**DOMINION NUCLEAR CONNECTICUT, INC.**  
**MILLSTONE POWER STATION UNIT 3**  
**RELIEF REQUEST IR-3-04, RESPONSE TO REQUEST FOR ADDITIONAL**  
**INFORMATION FOR ALTERNATIVE BRAZED JOINT ASSESSMENT**  
**METHODOLOGY**

**10 CFR 50.55a REQUEST NUMBER IR-3-04, REV. 1**

**DOMINION NUCLEAR CONNECTICUT, INC.  
MILLSTONE POWER STATION UNIT 3**

**RESPONSE TO THE REQUEST FOR ADDITIONAL INFORMATION ON USE  
OF A BRAZED JOINT STRUCTURAL INTEGRITY METHODOLOGY**

Figure 7: Three Inch Braze Field Sample Test Curve

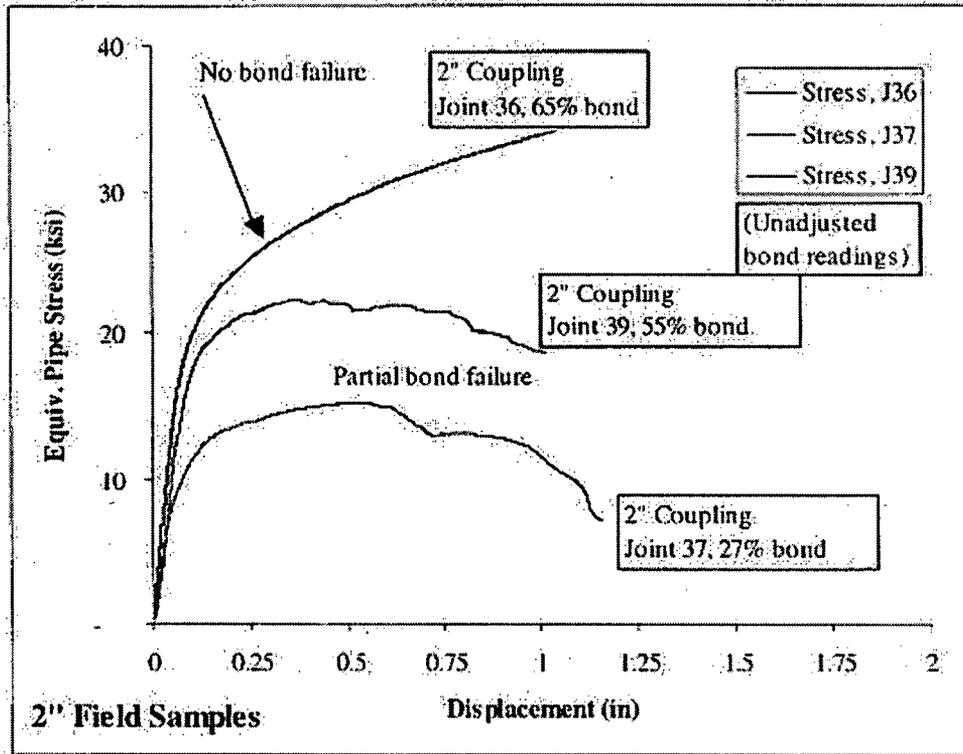
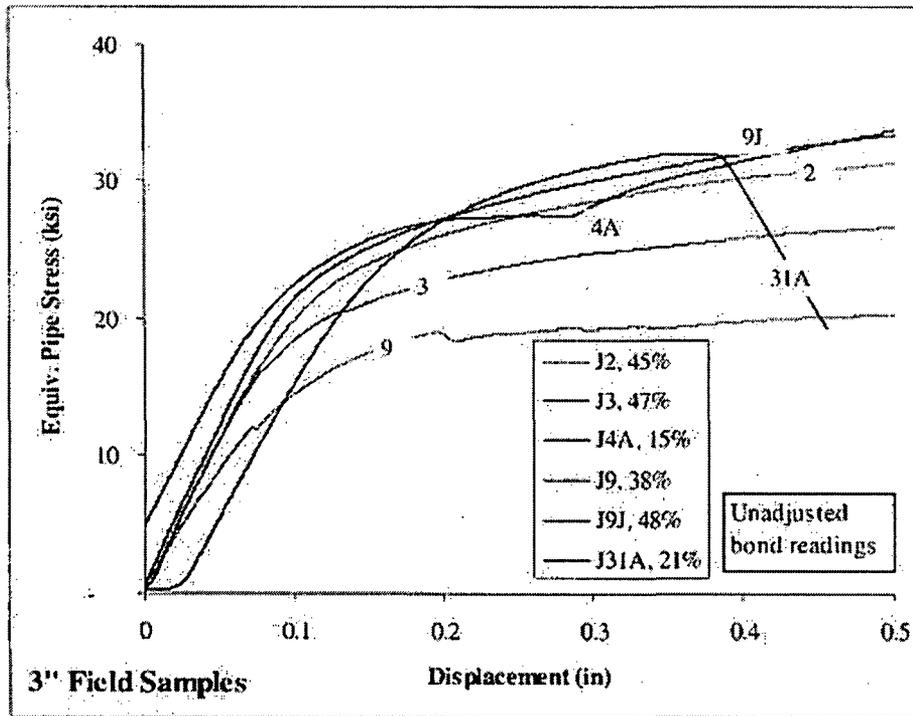
The NRC staff notes that there is significant data scattering in the test results of field samples of brazed joints as shown in Figure 7 of Attachment A to Enclosure 1. Provide reasons for the observed data scattering and discuss its impact on the reliability of bond level determined by UT examination.

Figure 7 shows load deflection curves for the several samples, and it exhibits expected variations that are based on percent bond. Figure 9, related to Figure 7, shows data scatter at adjusted bond levels below 50%; however, all data points are above the acceptance criteria. The figure shows some three inch samples with data well above acceptance threshold. The three inch samples have a relatively large meniscus fillet at the face of the joint. The scatter for three inch samples that is shown in the figure appears to reflect how this fillet characteristic is not credited for strength in the evaluation methodology. Also, the percent adjustment at low bond readings is an

almost 10% reduction on measurements that is an added conservative adjustment to the true bond. The aggregate of such conservatisms result in a relatively large data scatter while still validating the intended margin factor of 1.5.

Three Point Bending Test Apparatus  
FIGURE 1

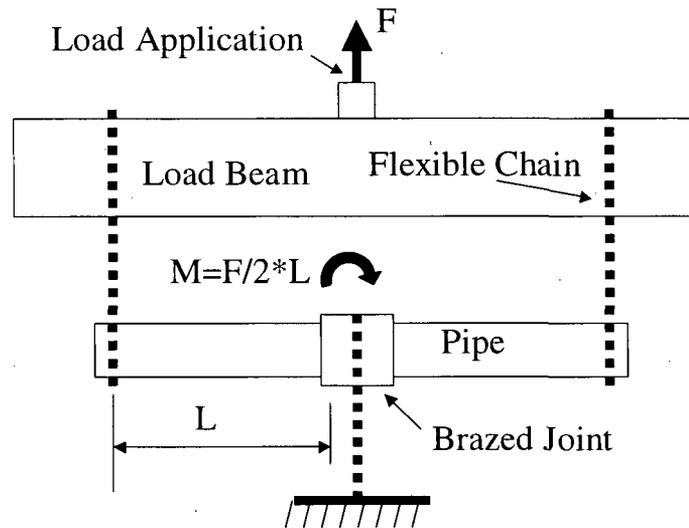
The NRC staff notes that all brazed joints in the program were tested by three-point bending with the brazed fitting in the middle of the configuration. Provide the technical bases for the selection of this testing method to evaluate the strength of the subject braze joints. Also, discuss the limitations and uncertainties of using this testing method to evaluate the bond strength of the braze joints given that the test sample is a composite of fitting, piping and braze materials and a bending load is applied to the sample. In AWS C3.2, "Standard Method for Evaluating the Strength of Brazed Joints," a tensile testing method is recommended. Describe in detail, including sketches as applicable, how the three-point bending test was performed and provide a sample calculation to show how the test data was collected and evaluated. You stated in page 1 of Attachment B to Enclosure 1 that the load transfer between pipe and fitting is primarily by shear through the braze filler. Provide a discussion of why the three-point bending test is an acceptable method to evaluate the bond strength of the brazed joints.

these loadings are not the most severe when there is any non-uniformity of the bond. Figure 1 is a diagram of this testing configuration.

The testing configuration that was used, which includes the pipe, fitting and braze, is an optimal model for simply and predictably determining the structural integrity of the joint. The fact that the piping deformation and deflection sometimes governs the limit load means that the piping cannot exert enough load to exceed joint capacity.

TWO INCH FIELD SAMPLES  
**FIGURE 2**

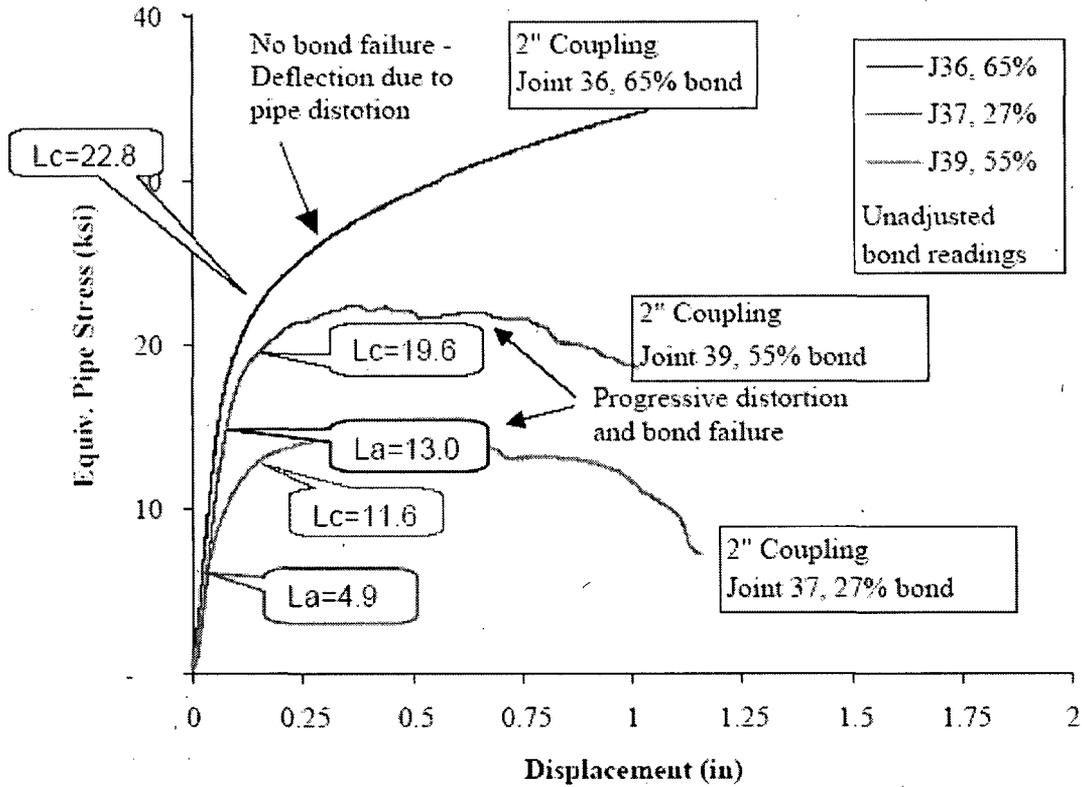
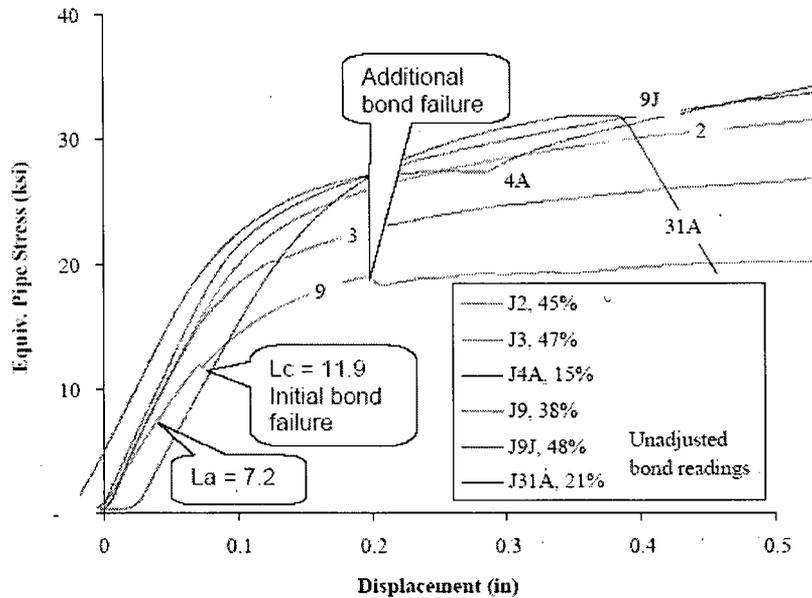
You stated in Section 4.1 [Attachment D of Enclosure 1] that all test items (refer to Figure 4 in Attachment A) achieved their test collapse load at a load well above that which would be predicted for a 5-ksi braze shear strength. Provide details regarding how the test collapse load is calculated from an assumed 5-ksi braze shear strength. Show how the test collapse load, piping collapse load and the bond failure load was determined. In the three-point bending test, explain how the failure of the bond, as to both local bond failure and total bond failure, was determined.

The test collapse load is derived from the load-deflection curve. The collapse load is defined in ASME III, Appendix II, Section II-1430. Refer to Figures 2 and 3 below, which are annotated versions of Figures 6 and 7 of the original request.

Initial bond failure is detectable by a discontinuity or knee in the load-deflection curve. This is indicated by Lc in the figures. The discontinuity or knee is the ASME-defined test collapse load. La on the figures indicates the allowable joint load based on the submitted methodology. The difference between the La and Lc illustrates the margin in the overall methodology.

The minimum joint strength predicted from a 5 ksi braze shear strength is calculated using Formula (3) from Figure 2 in the request. Continuing the above example, with L.insert = 0.656 inches, D = 2.375 inches, and Z.pipe = 0.561 in<sup>3</sup>, the lower bound of joint strength for 100% bond is 25.9 ksi. For 61% adjusted bond in the joint 36 example, the joint strength is reduced to 15.8 ksi as listed in Table 1 for that joint.
